**SUPPLEMENT
TO THE
DRAFT FISH AND WILDLIFE COORDINATION ACT REPORT
FOR THE
MODIFIED WATER DELIVERIES TO
EVERGLADES NATIONAL PARK, FLORIDA
THE 8.5 SQUARE MILE AREA
GENERAL REEVALUATION REPORT AND
SUPPLEMENTAL ENVIRONMENTAL IMPACT STATEMENT:
ALTERNATIVE 6D**

Supplement Submitted May 9, 2000

RE: Second Supplement to the Draft Fish
and Wildlife Coordination Act Report
for the 8.5 Square Mile Area

Figure S.5.1 Hydroperiods and Average Depths for Plan 6D

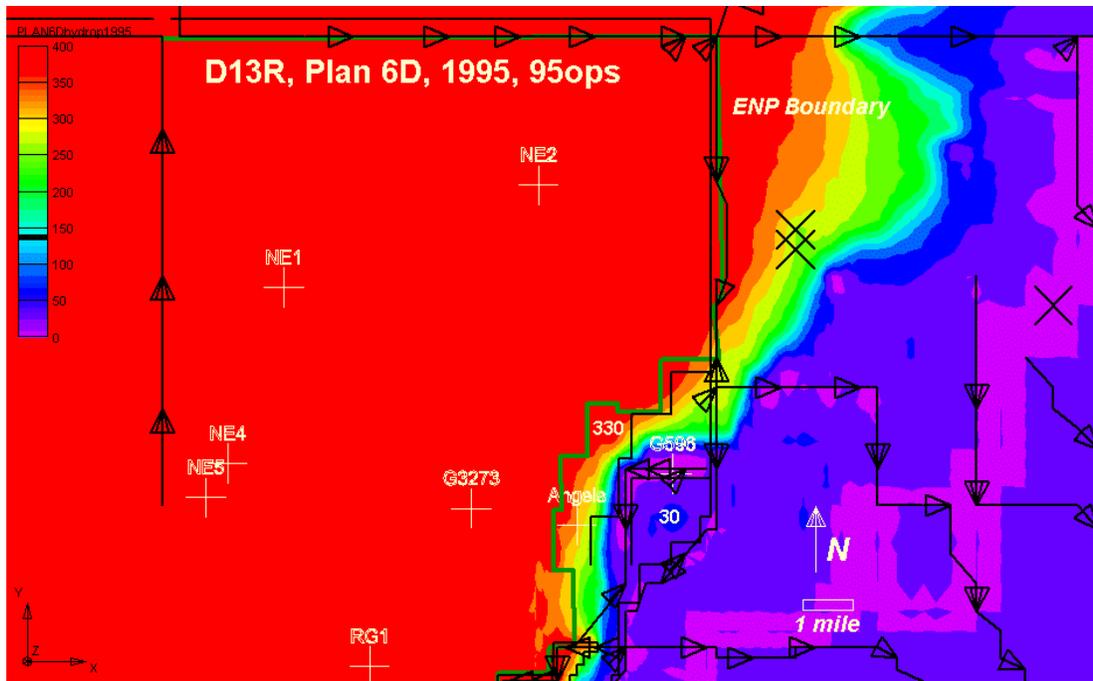
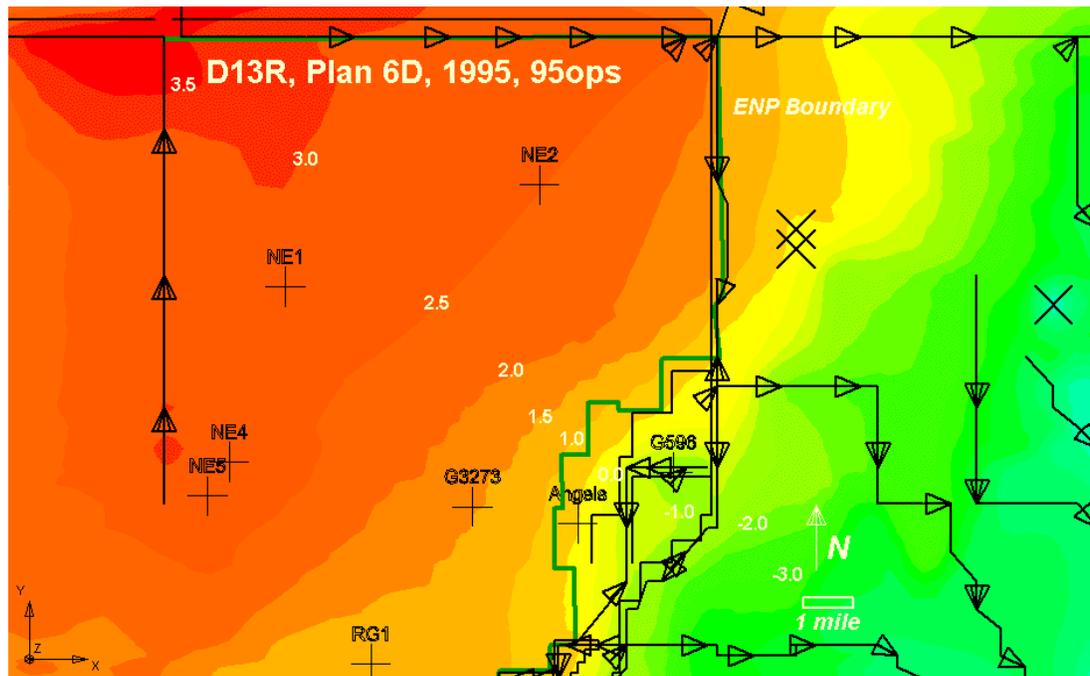
Restored hydroperiods in NESRS would be reduced in 282 acres of ENP under plan 6D (see Table S.5.1). Another critical measure of NESRS wetland restoration is water depth (Table S.5.1). Changes in water depth during the wet year for the various alternatives range from 0.1 feet to more than 1 foot over areas ranging from a few hundred acres to thousands of acres. Under Plan 6D, water depth is reduced in 5,845 acres in NESRS wetlands.

Flood mitigation was evaluated in terms of both increases in hydroperiod and average depth. The results are presented in Table S.5.3. Flood protection in the 8.5 SMA was evaluated for all of the plans, although only plans 3 and 6 were proposed as flood protection alternatives. Parcels were considered to receive flood protection if the water surface was below the ground surface during week 26 (the week in which peak flows occurred in the model). These results are presented in Table S.5.4. The flood protection zone for all plans except 6B and 6C is the entire 8.5 SMA (6,909 acres). For plan 6B, 6C and 6D, the flood protection zone is limited to the area east of the proposed canal. Only plan 6B would provide full flood protection. Plan 6D fails to provide flood protection to 40% of the designated protection zone. Plan 6D fails to mitigate in 541 acres of the designated protection zone.

Figure S.8.1 Difference in average water depths between the restored condition following full implementation of MWD and Alternative 1 (lowered water depths in NESRS by 0.1–1.0 feet relative to restored conditions in ENP following full implementation of MWD)

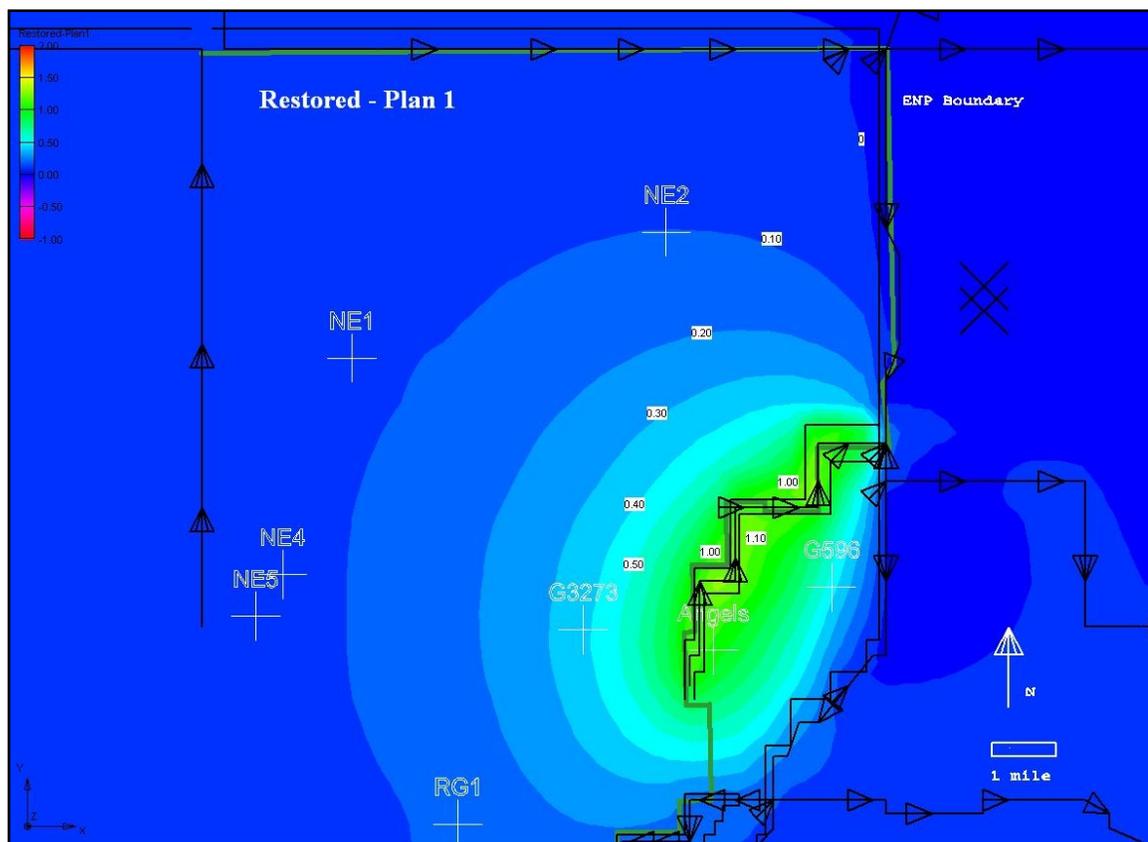
Alternative 1 performed poorly for all of the legislative requirement hydrologic performance measures. This alternative lowers water levels in both the 8.5 SMA and in NESRS (Figure S.8.1) that negate some of the benefits that could be derived from the MWD Project. It also does not provide full structural flood mitigation. In terms of the other objectives, the plan does not provide flood protection and is least compatible with future restoration. The plan performed poorly for wood storks and snail kites and had a WRAP score that reflected a loss of 2,765 functional units from existing conditions.

Figure S.8.4 Difference in average water depths between the restored condition following full implementation of MWD and Alternative 6B

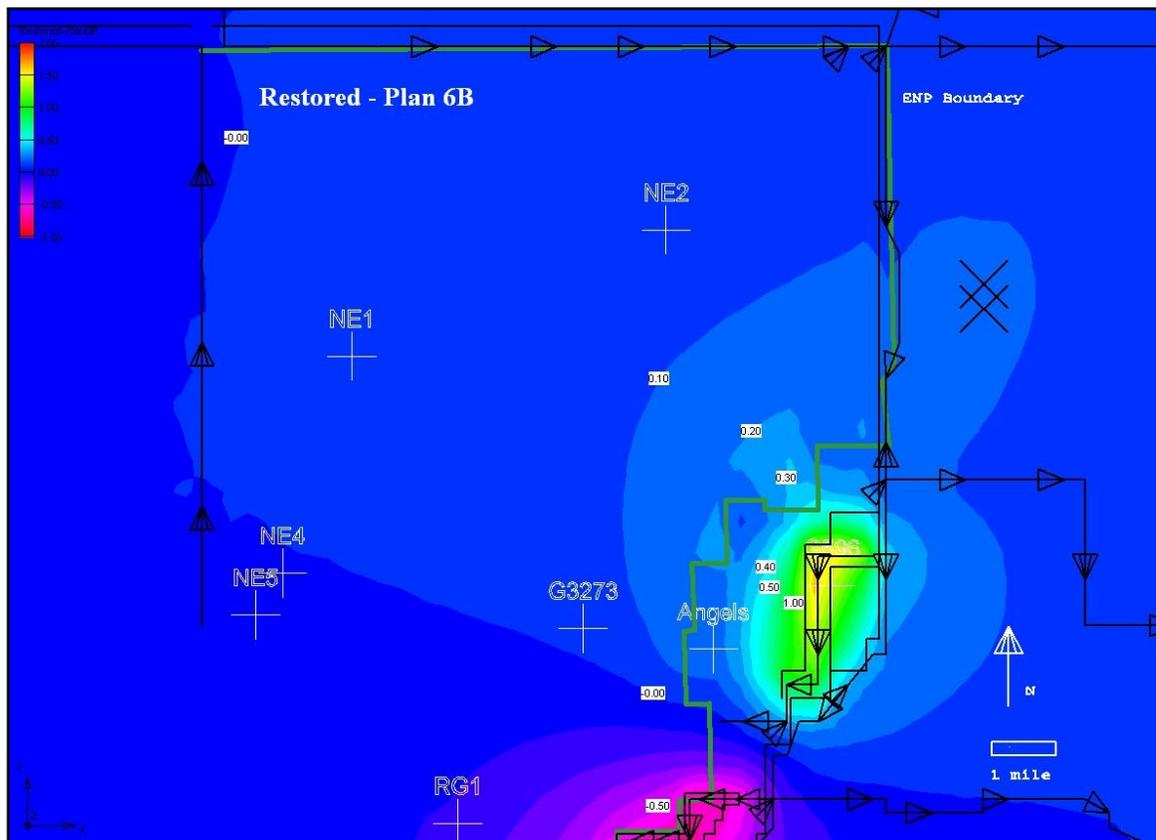
Alternative 6B reduces the spatial extent of lower water levels in NESRS by moving the canal and levee alignment to the east, but it still would reduce water depth over 8,000 acres in NESRS, reducing habitat for the endangered snail kite (Figure S.8.4). Limiting the protected area to the higher elevations in the 8.5 SMA would allow attainment of full flood protection. In providing 1-in-10 year flood protection to the residents, development is expected to increase and the any future projects related to restoration would have to maintain that level of flood protection. This may require increases in pumping to accommodate the relocation of S-356. This increased pumping would cause additional reductions in water depths in NESRS and additional losses of snail kite habitat. Once this 1-in-10 year flood protection is provided, there would be no potential for restoring water levels to the historic peripheral wetlands in the 8.5 SMA (Figure 9 of the Draft CAR). Performance was moderate for snail kites. The WRAP score for Alternative 6B suggests implementation of this alternative would result in a net gain of 1,606 functional units.

Figure S.8.5 Difference in average water depths between the restored condition following full implementation of MWD and Alternative 6C (lowered water depths in NESRS by 0.2 – 1.8 feet relative to restored conditions in ENP following full implementation of MWD)

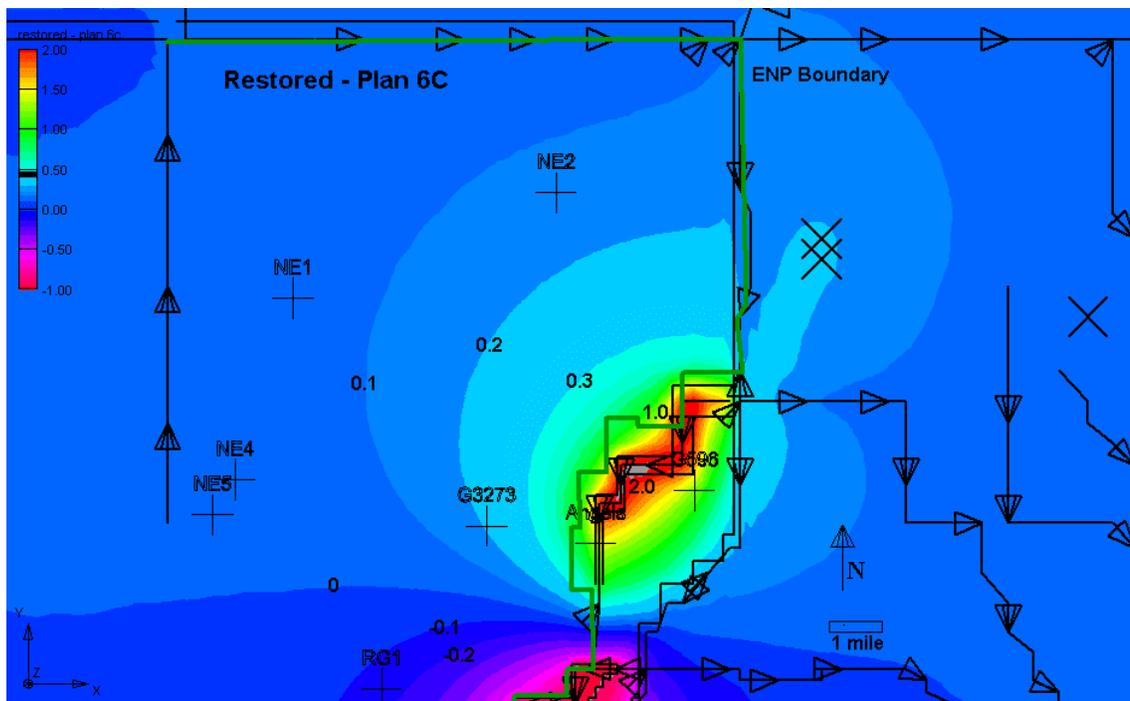
Alternative 6C performed poorly in mandatory hydrological performance measures related to restoration of NESRS, decreasing water depths in more than 27,000 acres in NESRS (Figure S.8.5). The plan provided full flood mitigation but fails to provide flood protection for 3,452 acres, 66% of the designated flood protection zone. Alternative 6C drastically decreases the extent of marl-forming wetlands due to the placement of the canal and levee in the middle of the existing marl forming wetlands. This causes the loss of 75% of the existing marl forming wetlands in the study area (556 acres). Alternative 6C is more compatible with future restoration than Alternative 1 because it moves water south into the C-111 project, but it is still less compatible than other alternatives. This alternative would provide the perception of flood protection, however, adequate flood protection would not be provided and therefore is not viewed as a sustainable solution. The alternative performed poorly for wood storks and snail kites. The WRAP score reflected a loss of 1,215 functional units from existing conditions.

Figure S.8.6 Difference in average water depths between the restored condition following full implementation of MWD and Alternative 6D (lowered water depths in NESRS by 0.2 – 0.3 feet relative to restored conditions in ENP following full implementation of MWD)

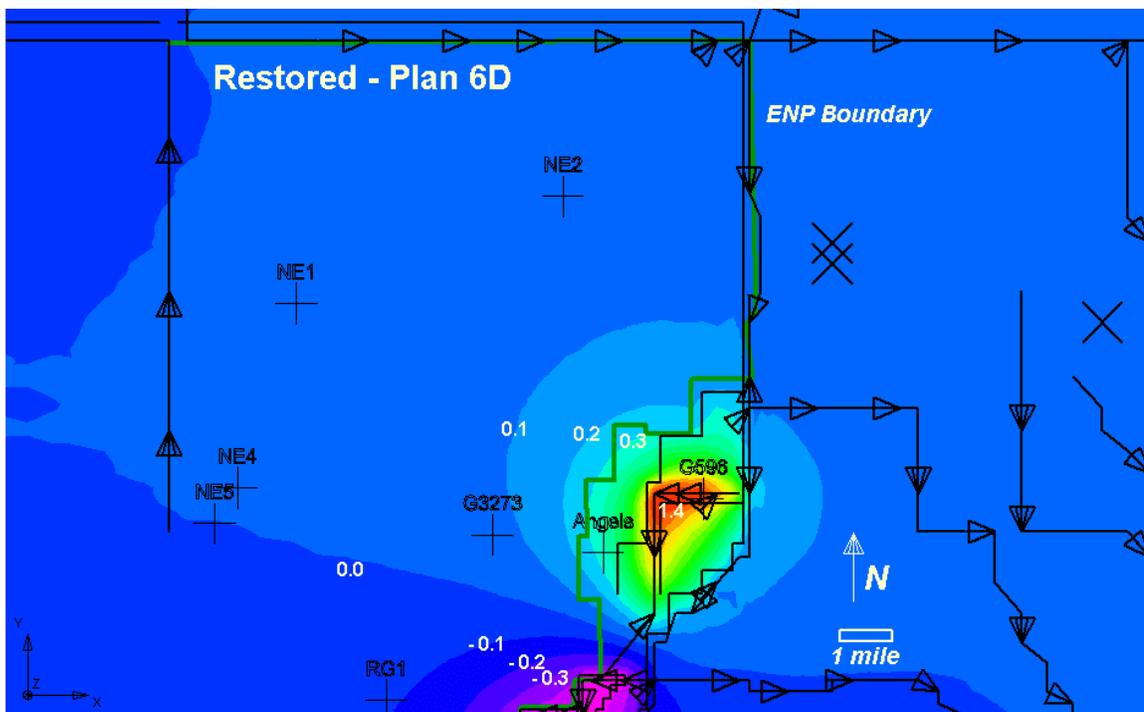
Alternative 6D reduces the spatial extent of lowered water levels in NESRS by moving the canal and levee alignment to the east (relative to Alt 1) and raising the water level maintained in the mitigation canal (relative to 6B). These changes cause Alternative 6D to perform poorly in mandatory hydrological performance measures related to flood protection. The plan fails to provide mitigation for 540 acres within the flood protection zone and fails to provide flood protection for 1,492 acres, 40% of the designated flood protection zone. The predicament of providing flood protection to some of the residents while offering no flood protection to others serves to aggravate the already tense canal management issues related to the operation of the South Dade conveyance system. During periods of heavy rainfall, residents will feel they are being treated unfairly, since they are flooded while their neighbors are being protected. Ultimately this will lead to increased pumping at S-357, reduced water levels in the mitigation canal and draw-downs in ENP similar to those in alternative 2B and 6C.

Figure S.9.1 Changes in Water Depths and Hydroperiods When all Alternatives Were Compared to the No Action Alternative (Alternative 1)

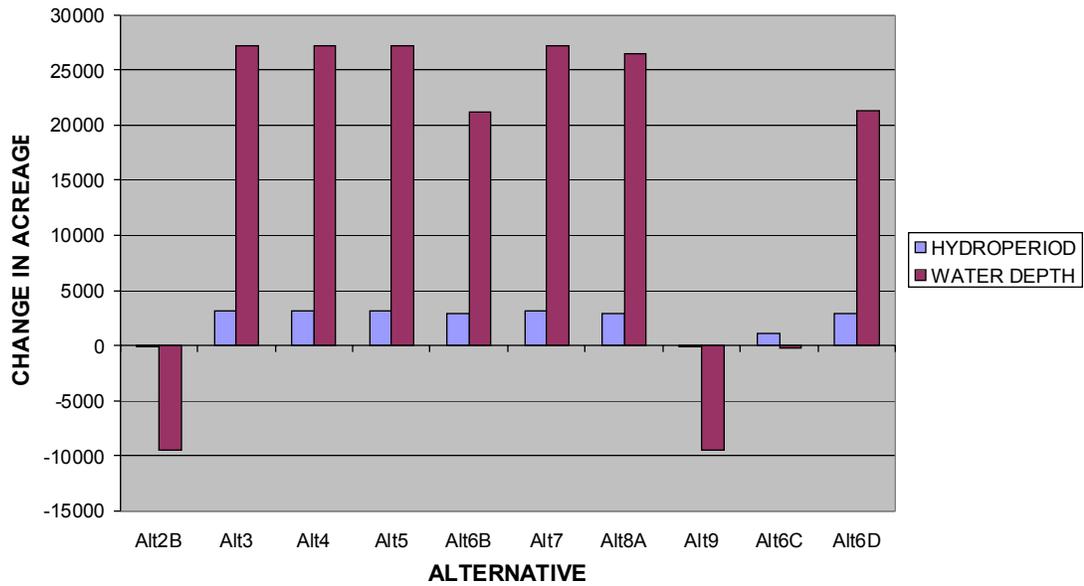
As seen in this figure, Alternatives 2B and 9 performed worse than Alternative 1 for changes in hydroperiod. Alternative 6C performed similar to Alternative 1 for the hydropattern performance measures. Only minor changes were noted for the water depth comparison for these two alternatives. For this reason, it is the opinion of DOI that Alternatives 2B and 9 provide no supplemental benefits for the ecosystem in general or ENP in particular.

Figure S.9.2 Changes in Flood Mitigation Parameters When all Alternatives Were Compared to the No Action Alternative (Alternative 1)

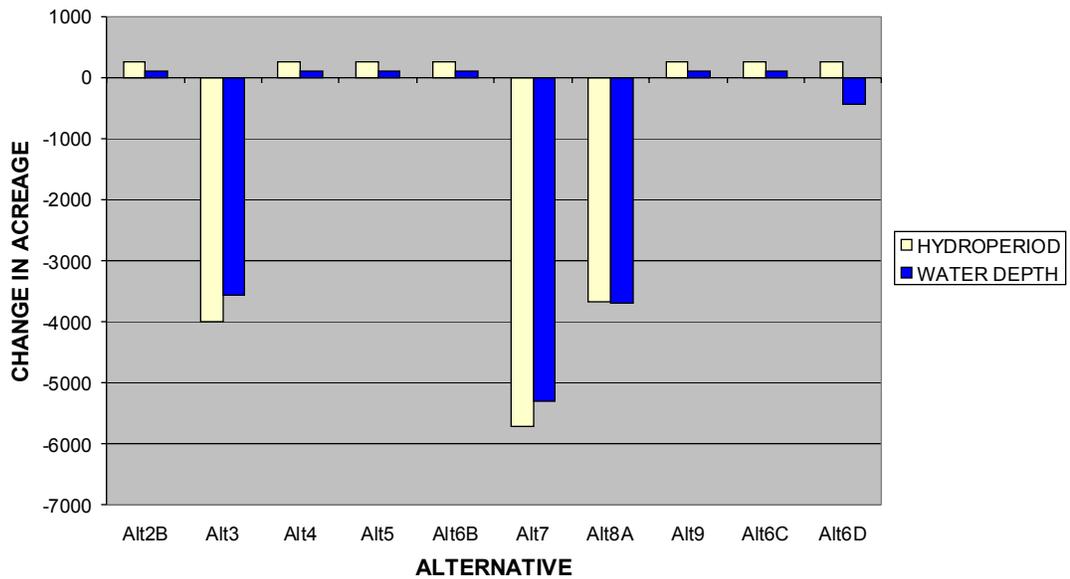
In contrast to the NESRS hydropattern parameters, Alternatives 3, 6D, 7, and 8A all would have diminished performance in the area of flood mitigation when compared to Alternative 1. For these reasons, Alternatives 3, 7, and 8A also would provide no supplemental benefits for the ecosystem or ENP, in that the marked decrease in performance for flood mitigation would not meet one of the legislative requirements of the MWD Project. It should also be noted that Alternative 7 would provide no flood mitigation to the 8.5 SMA because this alternative would only raise the existing road surface elevations. It is the opinion of DOI that this would result in a worsening of conditions when compared to the existing condition.
